March 28, 2022

Re: Mistis Properties Inc, 176 Virginia Road  
Site Plan Response Memo

This Memorandum responds to the outstanding Site Plan comments set forth in the Kellard Sessions Consulting, P.C. Memorandum, dated May 7, 2021. Kellard's comments are provided attached, Our responses are noted below in bold, blue and italics.  
Included here within:

PHOTOMETRIC PLAN N.T.S.

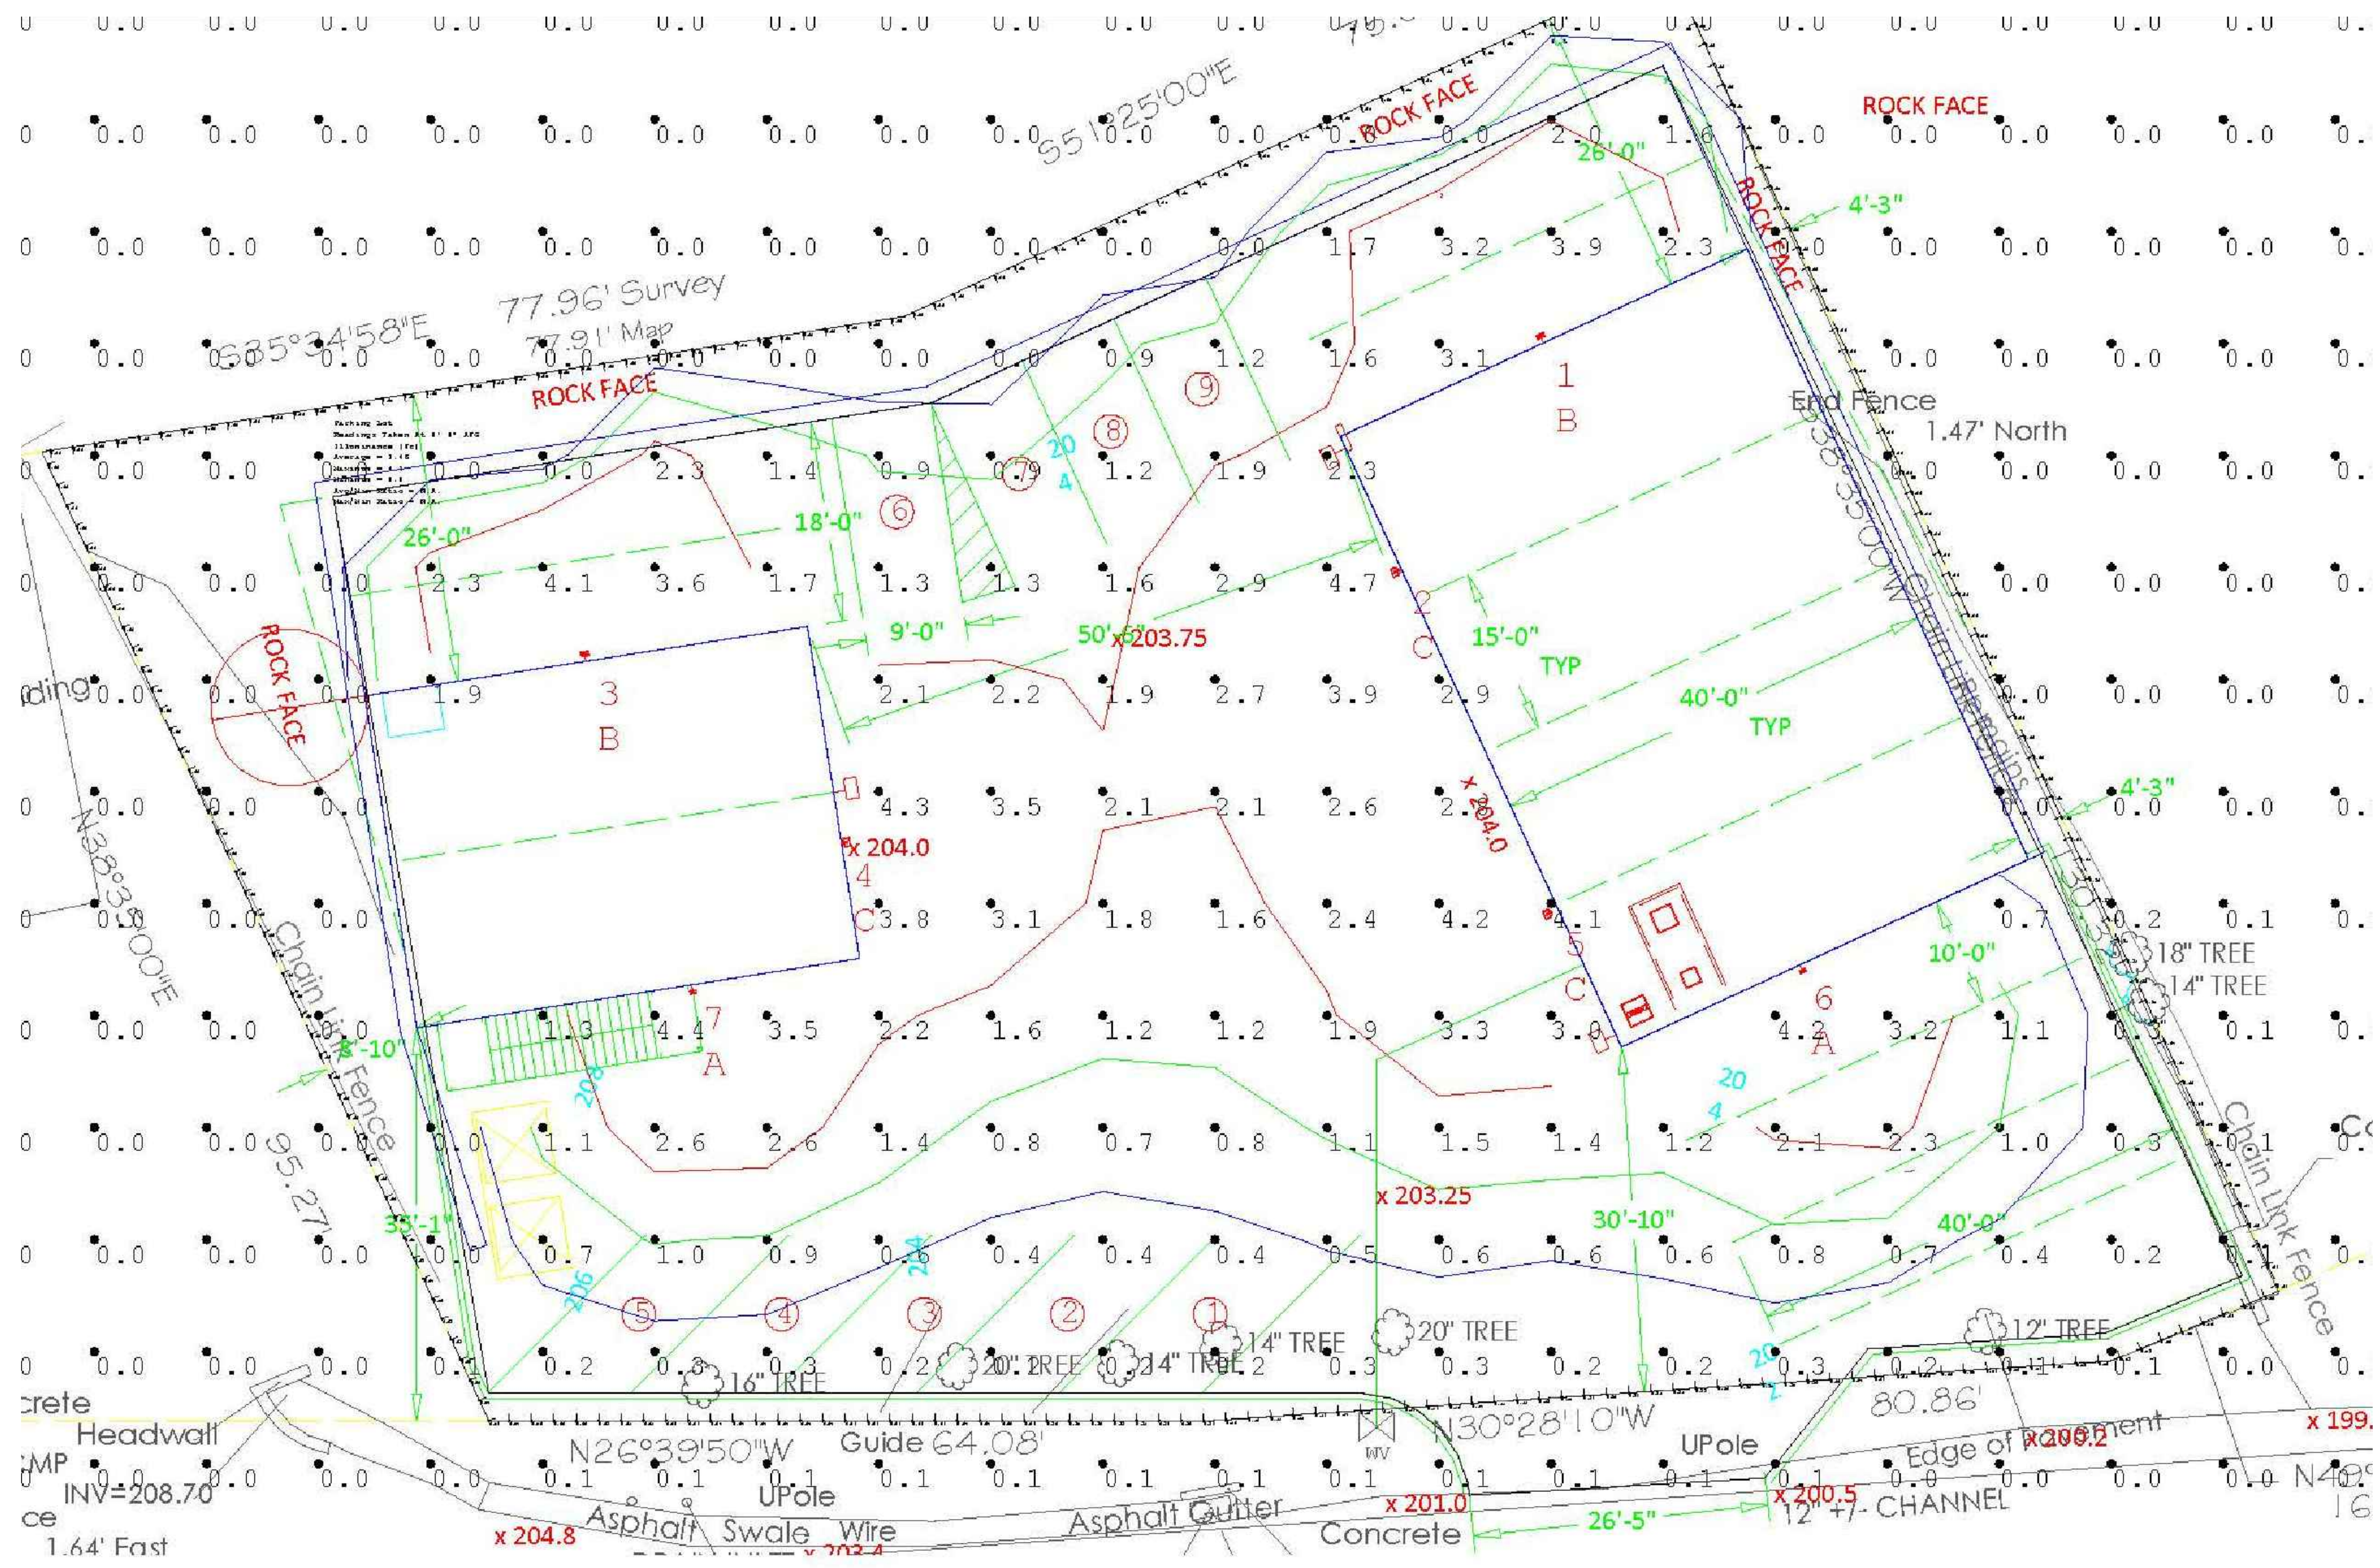
2. Provide a site lighting and photometric plan for review and consideration by the Planning Board include specifications and details of all fixtures, poles, and pole bases.  
*Plans were updated as per comment. (See Site Lighting & Photometric Plans, Schedules, Specifications and Detail on Sheet E-1 to E-3.)*

# PRE DEVELOPMENT

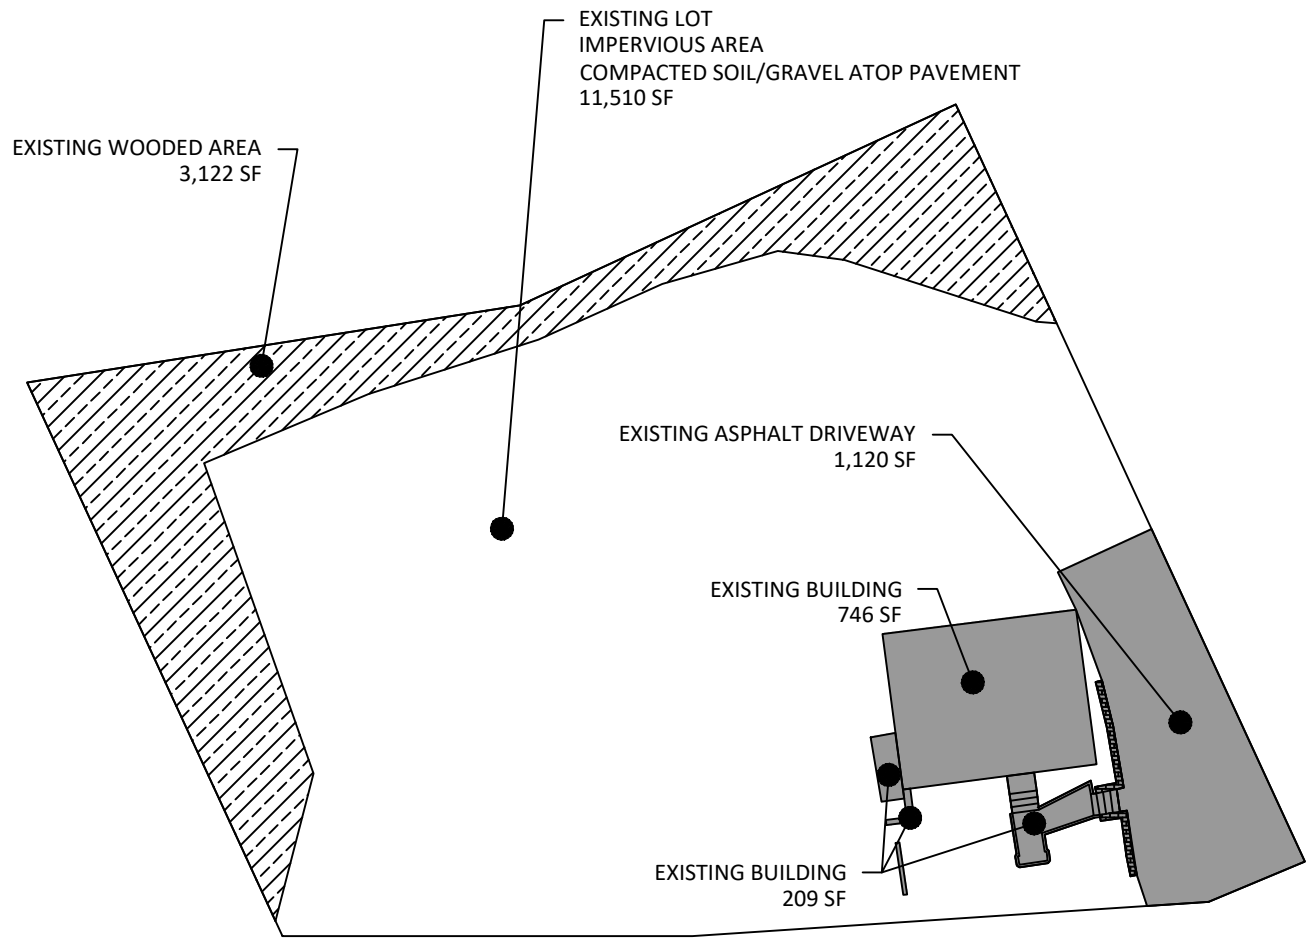
8. Drainage area maps shall be included in the Stormwater pollution Prevention Plan (SWPPP). The areas and cover types tributary to each sub-catchment shall be clarified.

*Plans were updated as per comment. (Please see the attached SWPPP)*
